Item 3.**Development Application: 349 Liverpool Street, Darlinghurst - D/2022/831**

File No.: D/2022/831

Proposal Summary: The application seeks development consent for the demolition of the existing residential flat building, tree removal, excavation and construction of a new residential flat building with 8 storeys, three basement levels, 15 car parking spaces, 14 apartments, rooftop communal and private open space, and associated landscape works including new tree plantings.

Figure 35: 3-dimensional axonometric drawing extract depicting the maximum 22 metre height plane applicable to the site, with compliant elements shaded in blue and non-compliant elements shaded in white

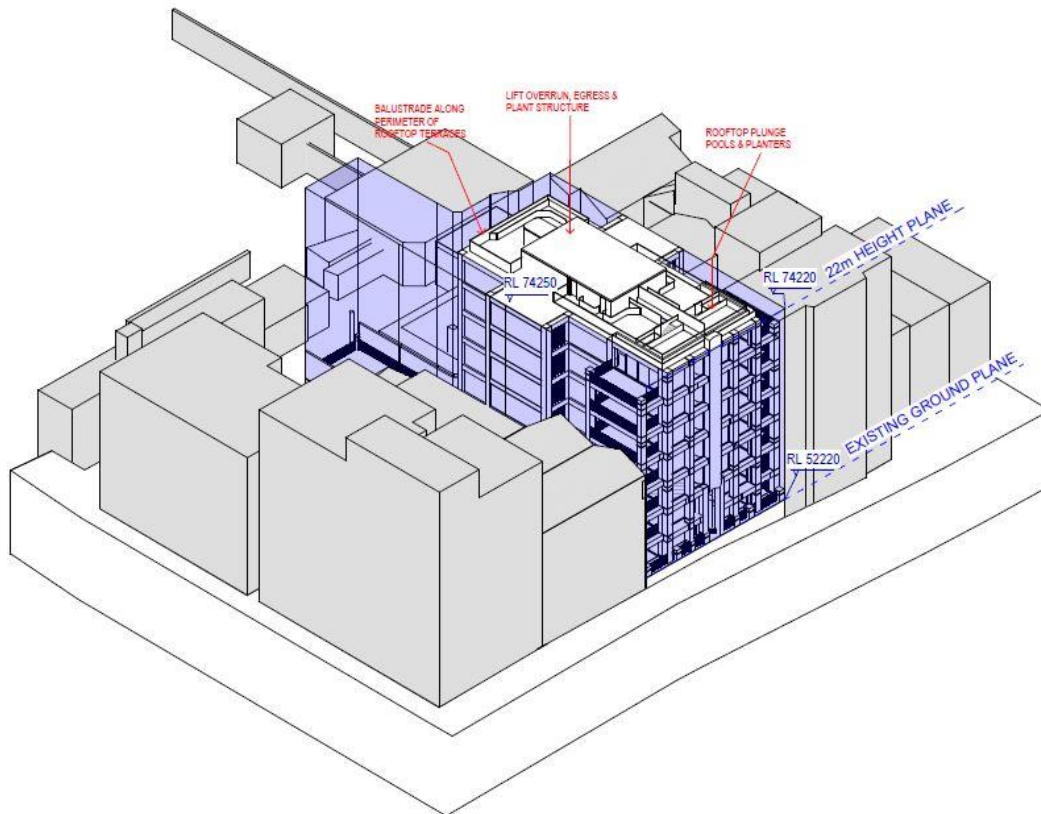
95. The site is subject to a maximum height of buildings development standard of 22 metres.
96. The proposed development has a height of 24.2 metres at the top of the lift overrun and stair access, which is a 2.2 metre (or 10 per cent) variation of the standard.
97. The extent of non-compliance with the development standard is depicted in the 3-dimensional axonometric drawing extract of the proposed development reproduced in the figure provided below.

Figure 40: West elevation drawing extract depicting the 3 metre building separation to the dwelling house at 1 Darley Place

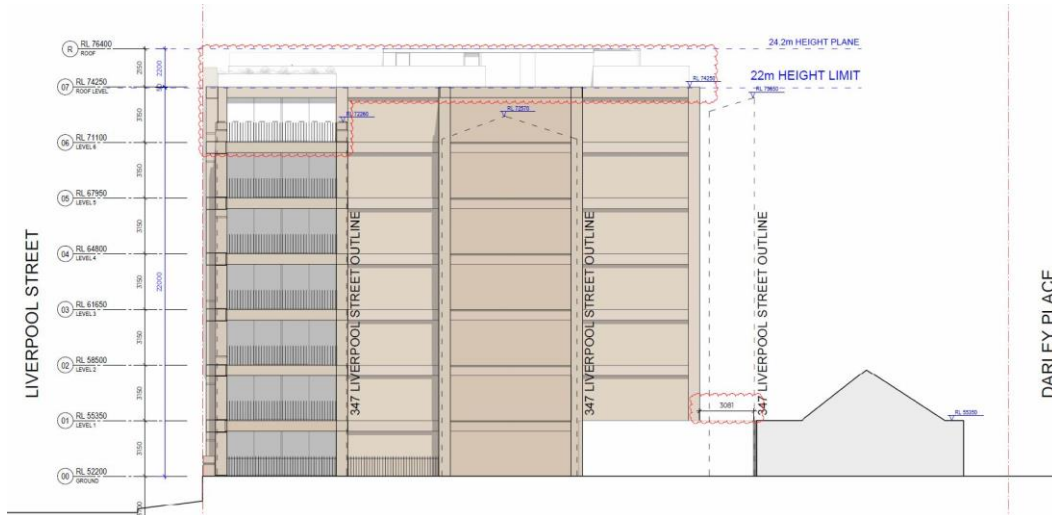
- (a) Setting aside the concern raised above in relation to the visual bulk, scale and mass of the proposal from a heritage perspective, the proposed setback from the rear boundary with the dwelling house at 1 Darley Place is a minimum of 3 metres at all levels, as depicted in the drawing extract reproduced in the figure below, where the ADG requires a setback of between 6 to 9 metres .

Figure 41: 3-dimensional axonometric extract from the architectural design report submitted with the application, depicting the privacy louvres proposed to apartment bedrooms

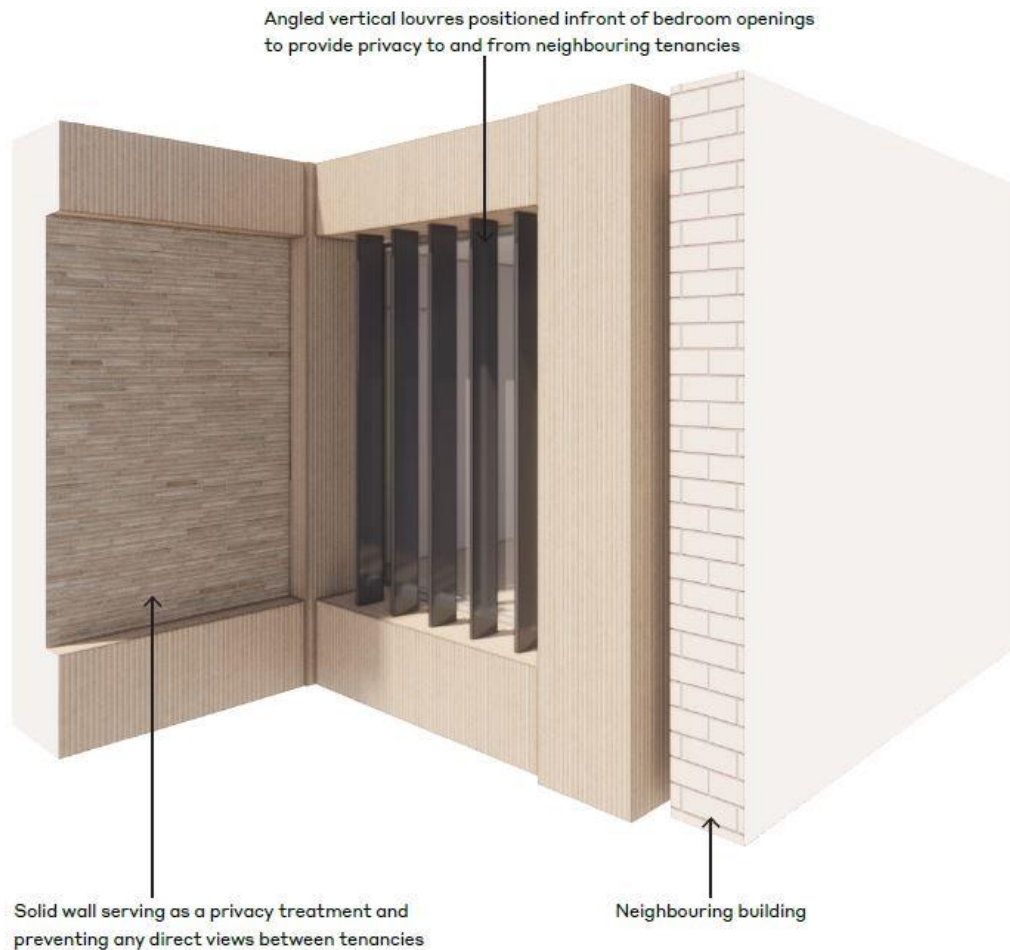
- (b) The extent of glazing to the rear facade is uncharacteristic in the locality and results in overlooking of neighbouring and nearby windows and private open space areas, with no design measures provided to mitigate against these potential visual privacy impacts.
- (c) The open design of the side balconies borrow amenity from the eastern neighbour, which may not be available in perpetuity, and do not propose any screening along the side elevations of the development. Unmitigated overlooking across the side boundary of the site is not supported.
- (d) The proposal relies on extensive privacy screens, as depicted in the drawing extract reproduced below, due to inadequate separation and extensive glazing. Insufficient detail on the design of these screens has been provided with the application to demonstrate mitigation.

Figure 42: Natural cross ventilation flow path diagram extract

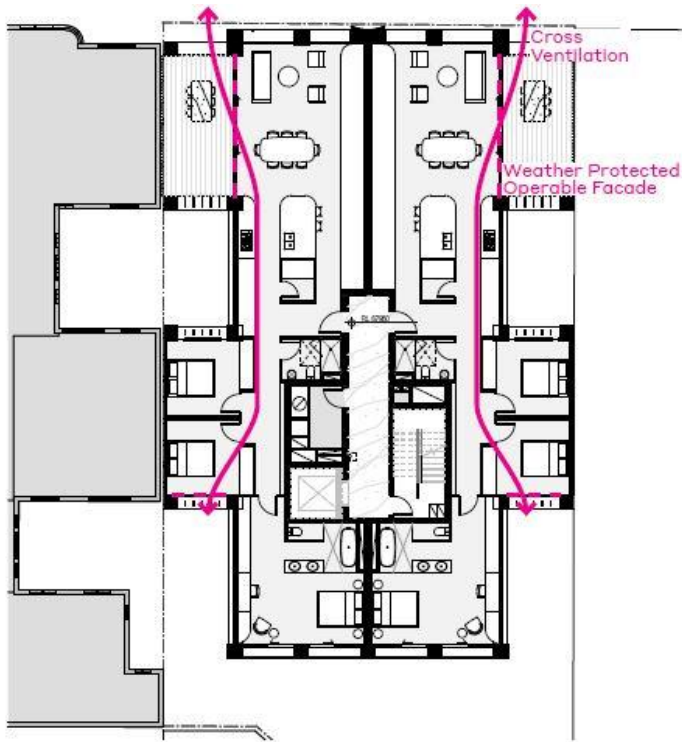
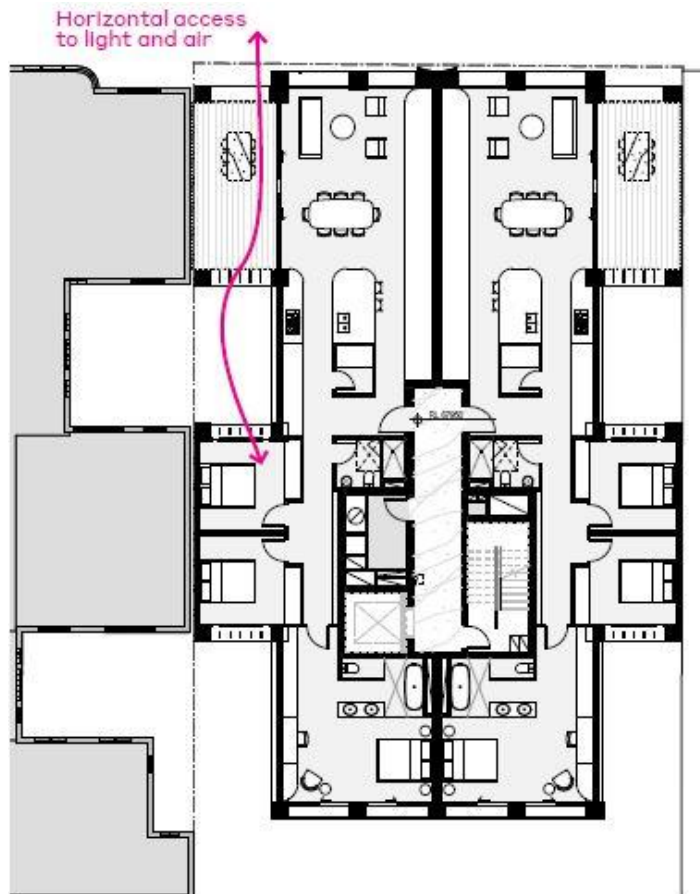
130. It is accepted that all of the proposed apartments are capable of achieving natural cross ventilation in principle, noting that the overall depth of the apartments does not comply with the relevant requirements of the ADG, which will reduce the efficacy of the cross through apartment design in this respect.

Figure 44: Garden bed detail depicting excessive soil mounding and insufficient soil depth

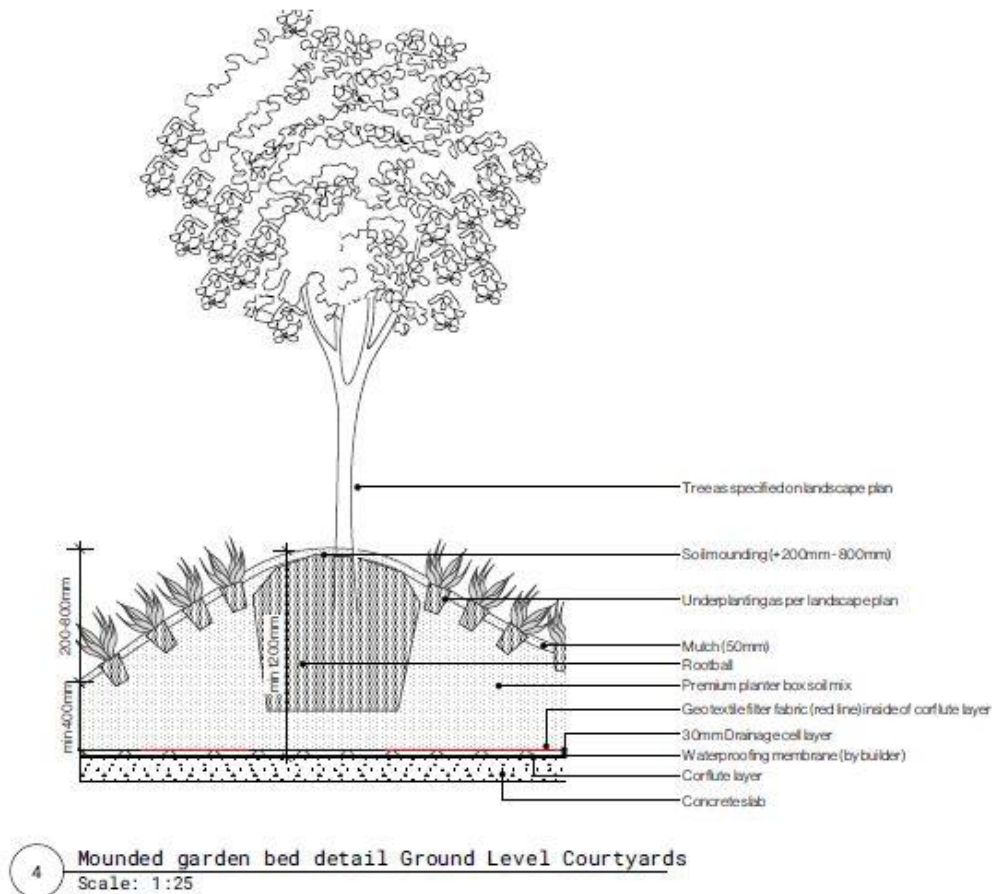
Excessive soil mounding to achieve soil depth is not supported, given that soil is organic and subsides over time, which can result in bare root balls and plant failure.

Figure 45: Stormwater management plan drawing extract, showing the proposed stormwater pipe (depicted in blue) running through the deep soil area at the rear of the site

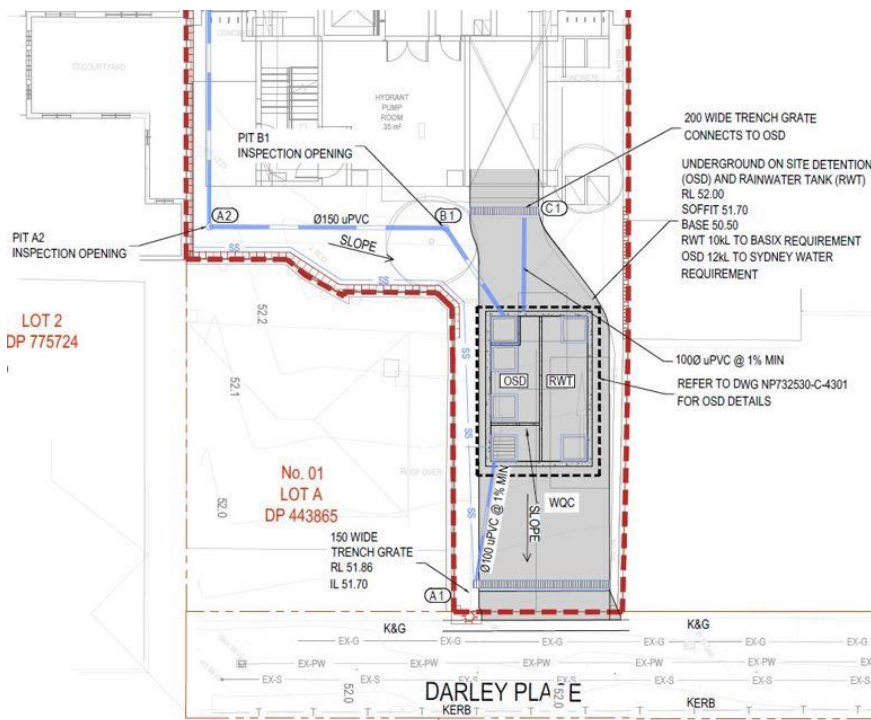
147. A stormwater pipe is proposed to run across the centre of the primary deep soil area and is in direct conflict with the location of proposed tree plantings, as depicted in the drawing extracts reproduced in the figures provided below.

148. These aspects of the proposal are not supported as it will result in compromised deep soil area design for the development and is contrary to the relevant objectives and controls of SEPP 65, the ADG, and the Sydney DCP 2012.

Figure 50: View from the roof top space of the 'Ballina' building at 5 Darley Street, Darlinghurst, looking west to the 'Mont Clair' building and Sydney Central Business District skyline

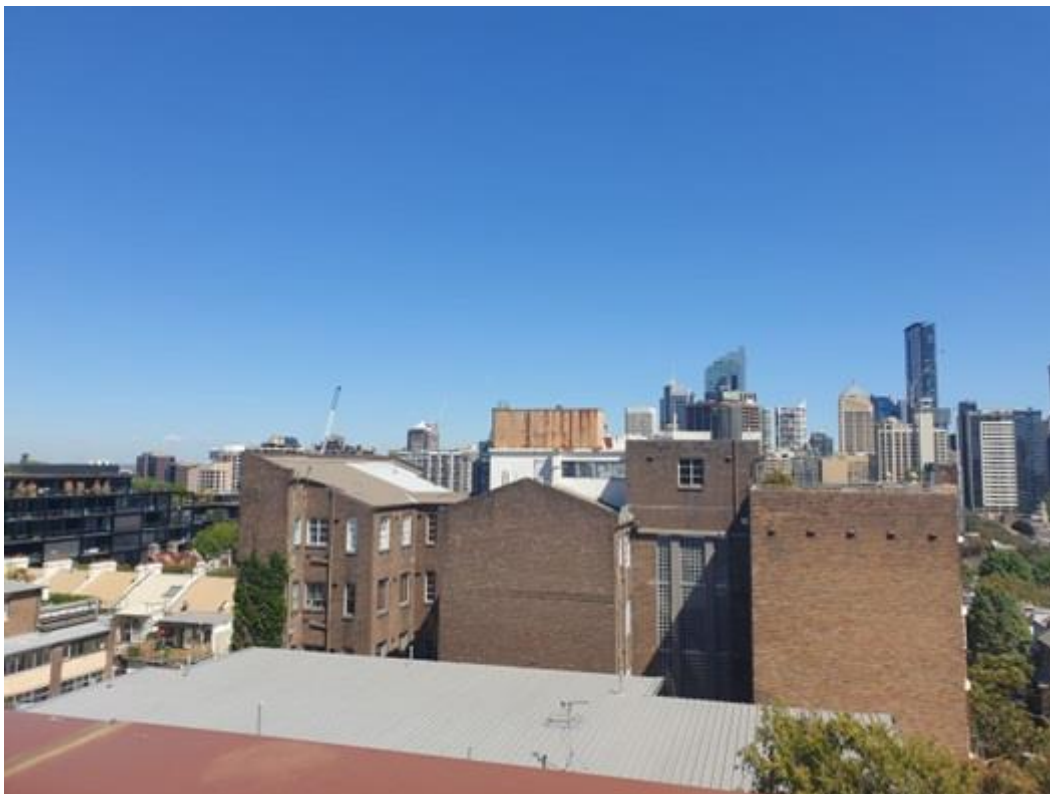
170. The impacts arise as a result of a proposal which does not comply with the maximum height of buildings development standard, the maximum storey height and street frontage height controls, and the building separation requirements applicable to the site.

171. The impacts on these existing views might be mitigated by a more skilful, or compliant design and, as such, they are unreasonable in the circumstances.
